Telegraph Road Intersection Design Workshop #1

Route 1 Improvements at Fort Belvoir

Meeting Notes

Meeting Date: January 29, 2012
Attendees: See attached list
Subject: **Route 1 Widening – Telegraph Road Design Charrette #1**

Route 1 / Telegraph Road

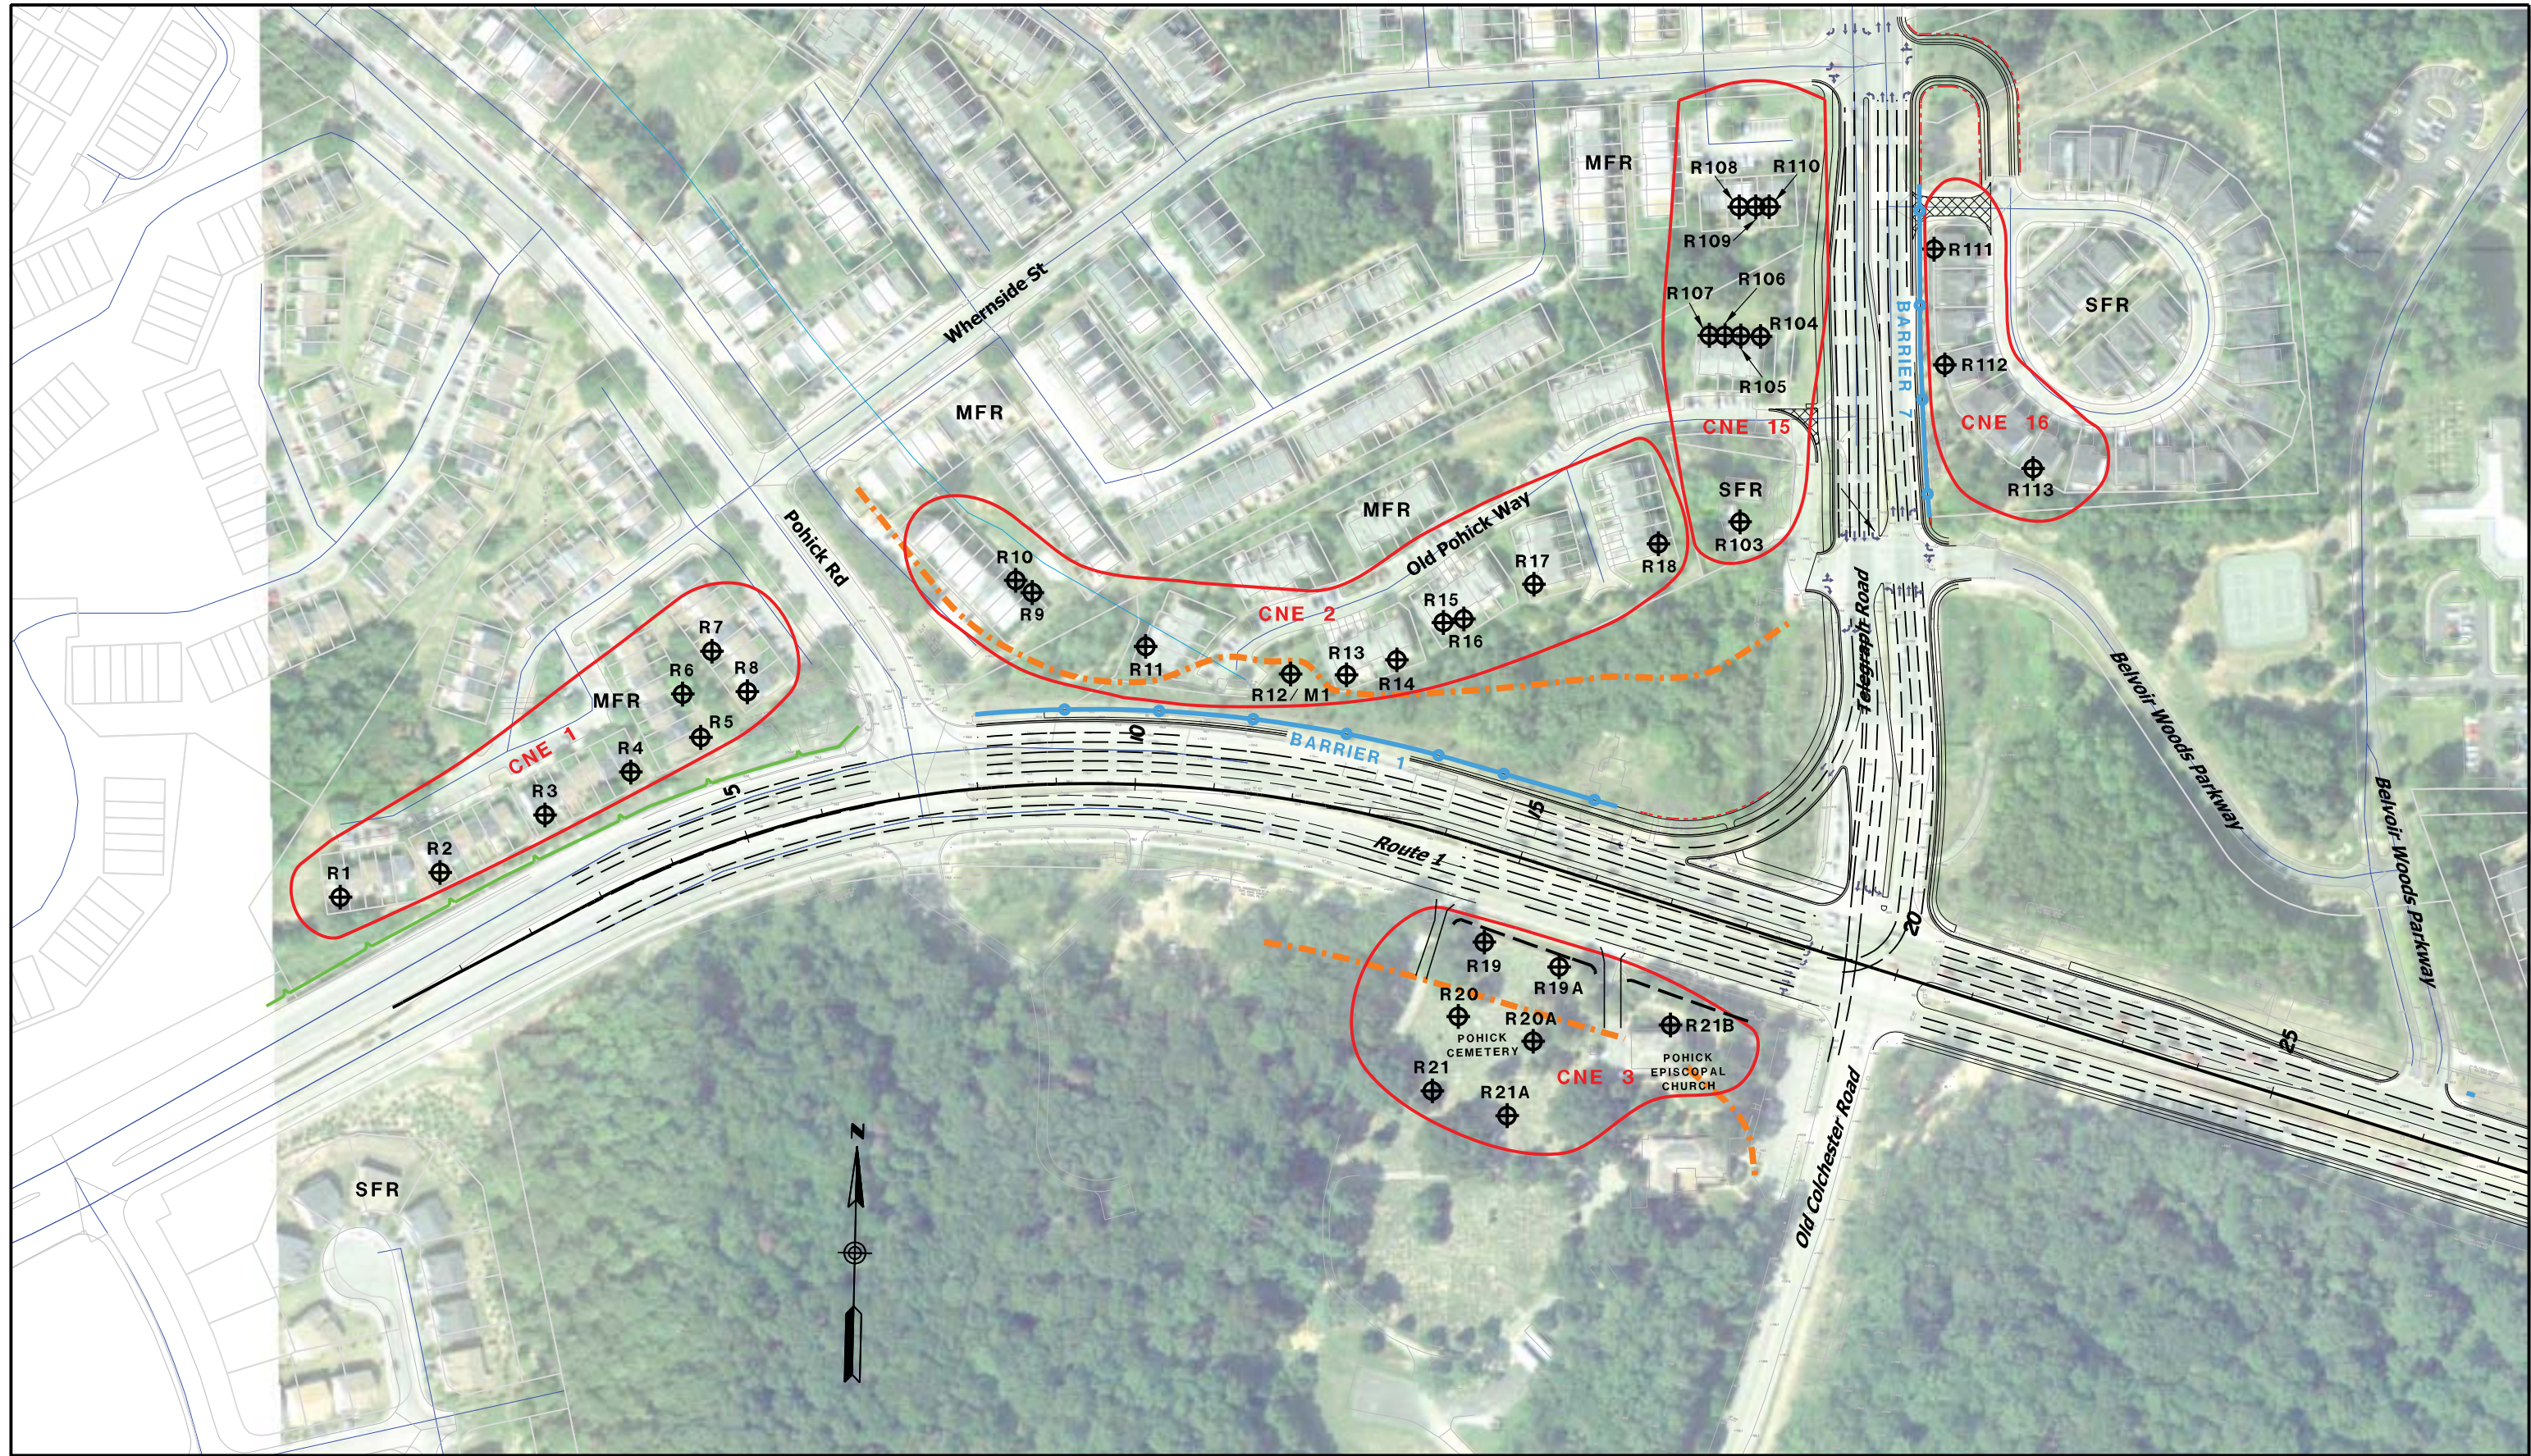
Discussed what the ponds look like, fencing, landscaping, maintenance access. Need to tone down the ponds in the historic district. Pawan (VDOT) said that there is a toolbox of best management practices that are acceptable for maintenance by the state. Bio-retention, dry detention, and extended dry detention are currently the best options. Underground BMPs are double the cost to maintain, so if you have available land for surface measures, that is preferable. If there is a constraint on right of way, then you can consider underground. VDOT policy says to avoid underground, not that it's not allowed. Assumed this is a dry detention pond, but concept was done without soil borings, so need those to confirm groundwater elevations.

Pawan said Contractor could address requirements within the hydrologic code area and not propose what is shown on the plan. PB confirmed that the ponds are designed very conservatively – the plans indicate outside limits. For example, Pond 1B is not required for quality – only for quantity.

VDOT wants ponds close to the road for accessibility, but also prefers that there not be a pond at every outfall, rather combine several outfalls.

- The design and appearance of the storm water management pond is important. As with the wall, it must be designed in a manner that blends into the landscape to the point that it is easily overlooked. This means a gentle slope and little to no rip-rap.

**ROUTE 1/ ALTERNATIVE B
 AT FORT BELVOIR PROJECT
 NOISE RECEIVER & BARRIER LOCATIONS**

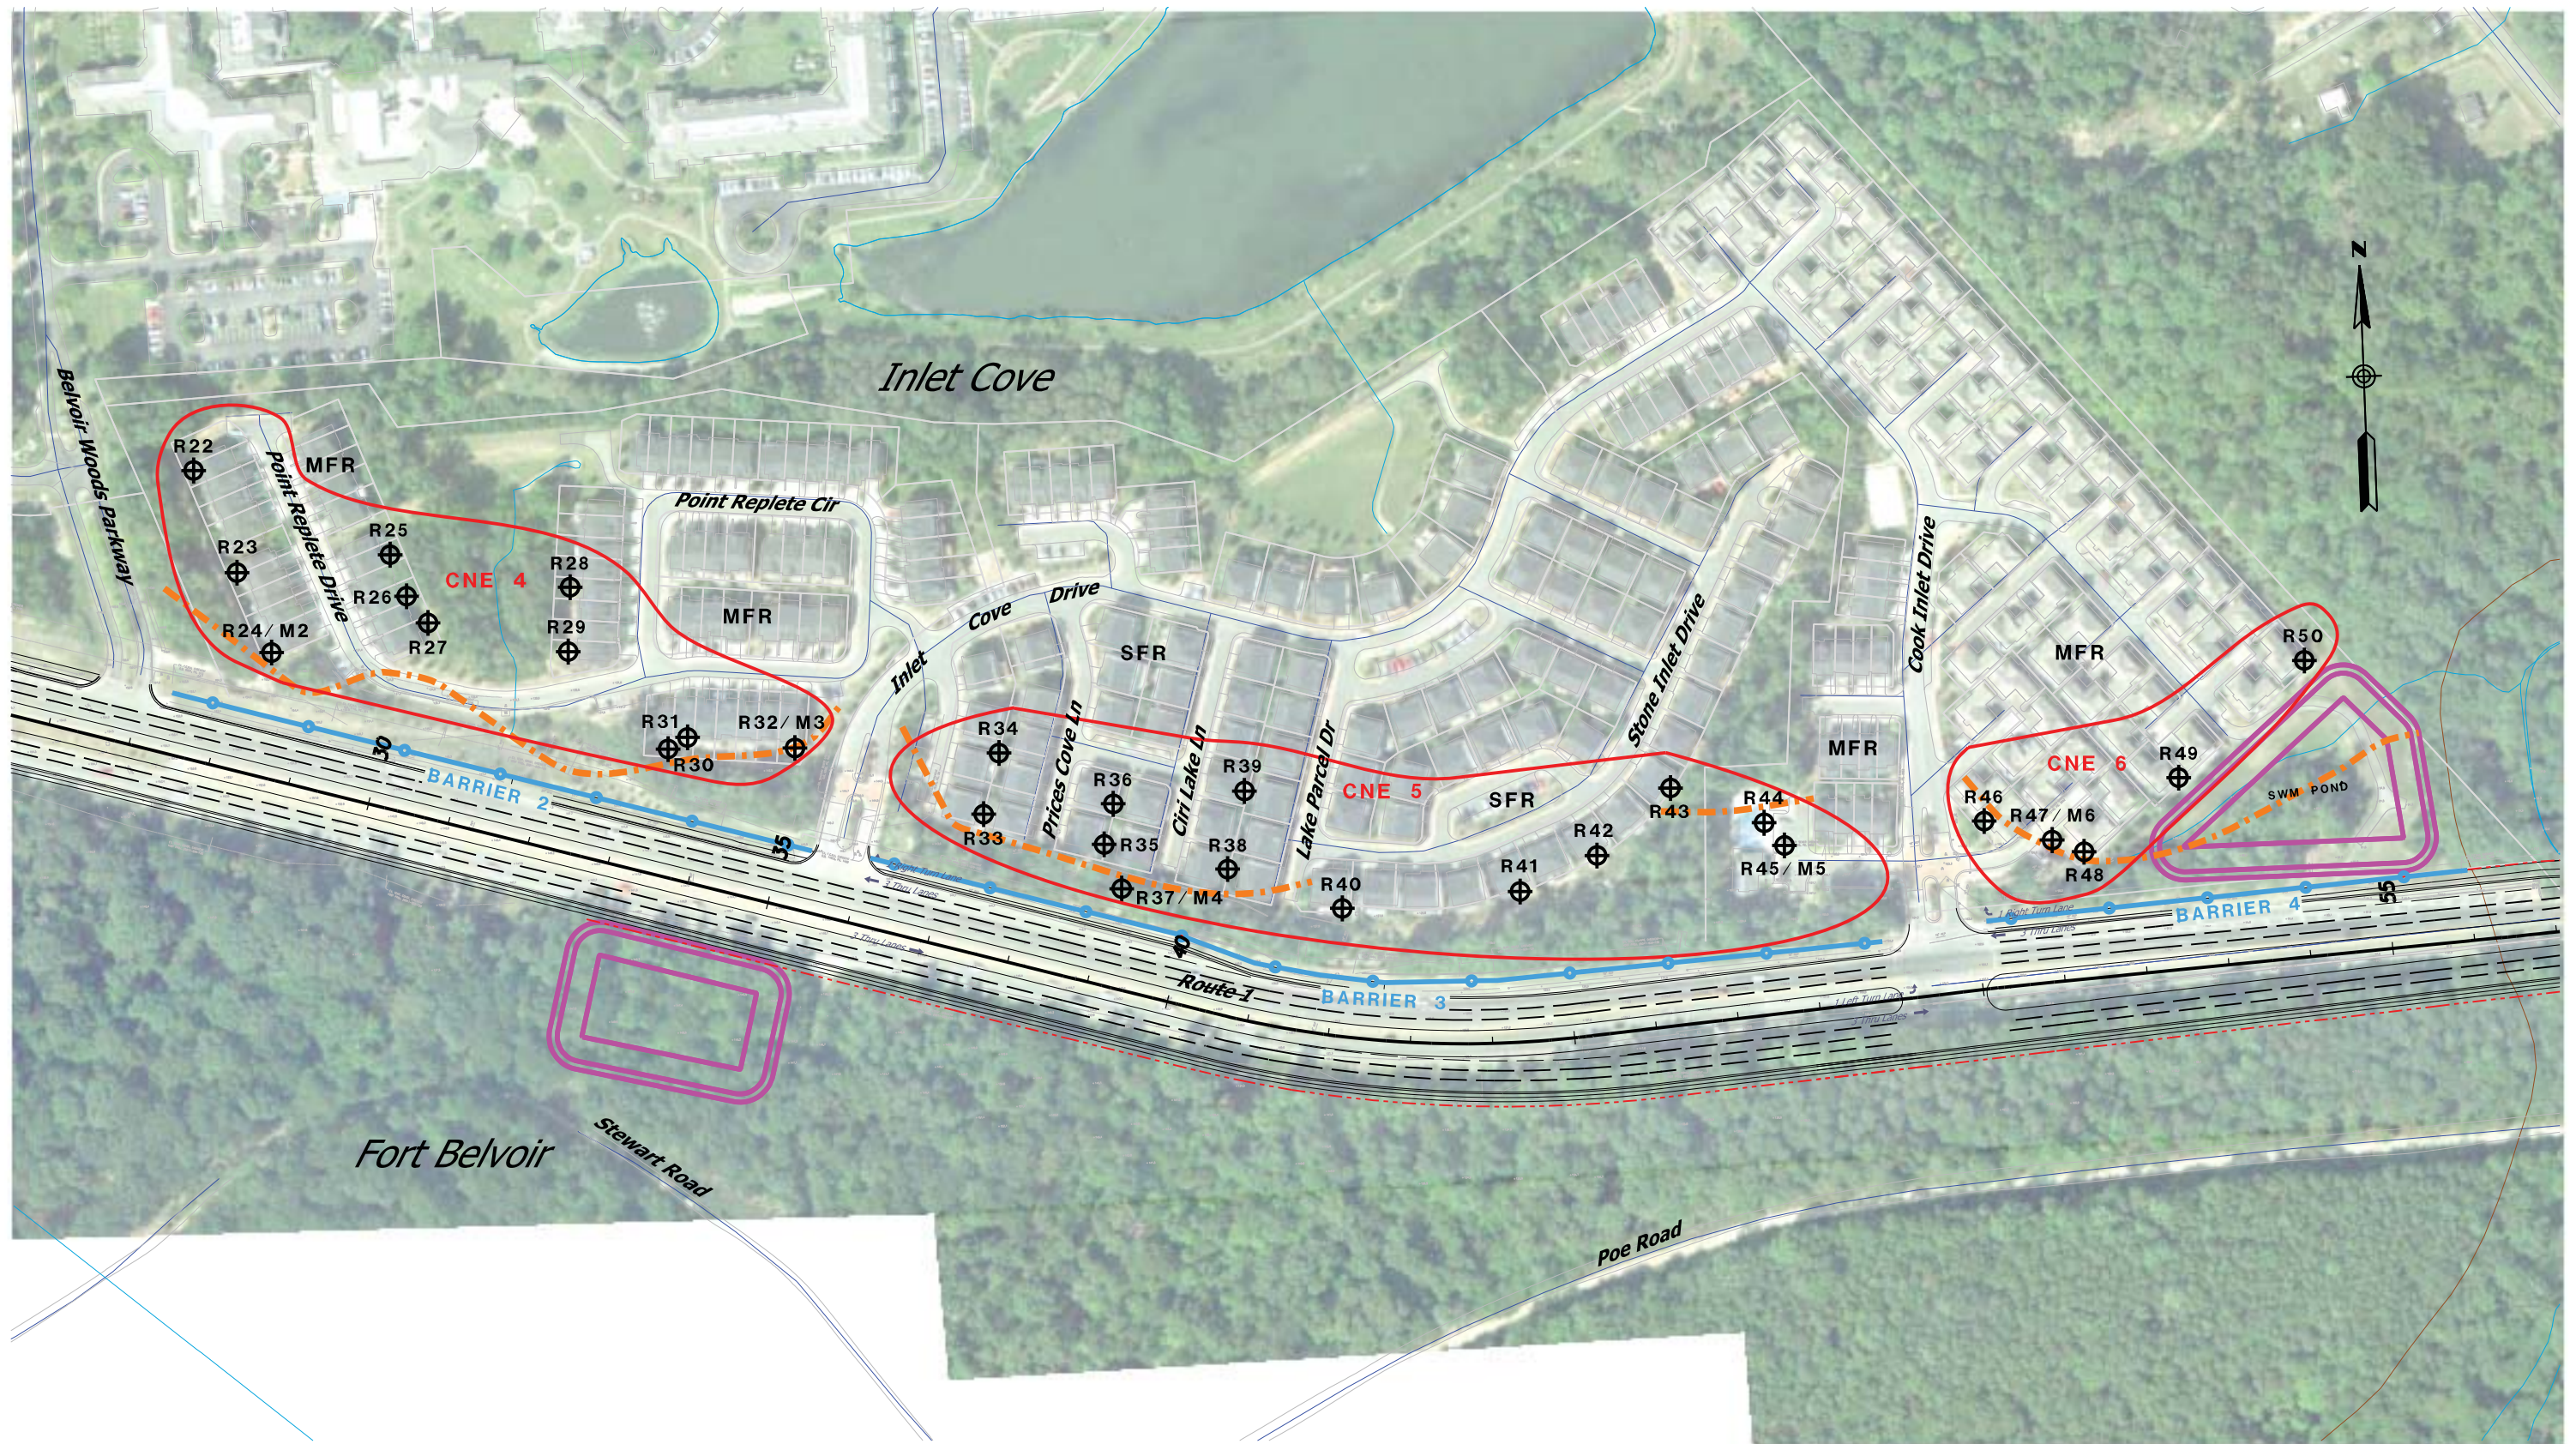
Q – Marc asked about height of wall across from Pohick Church.

A – It's in the noise report, but the thought is they are 8-10 feet – maybe 12-14'.

- Locate the sound wall as far away from Pohick Church as possible, that is, behind the storm water management pond.
- Construct a berm as high as the area between the wall and pond will allow. This will limit the size of the sound wall necessary.
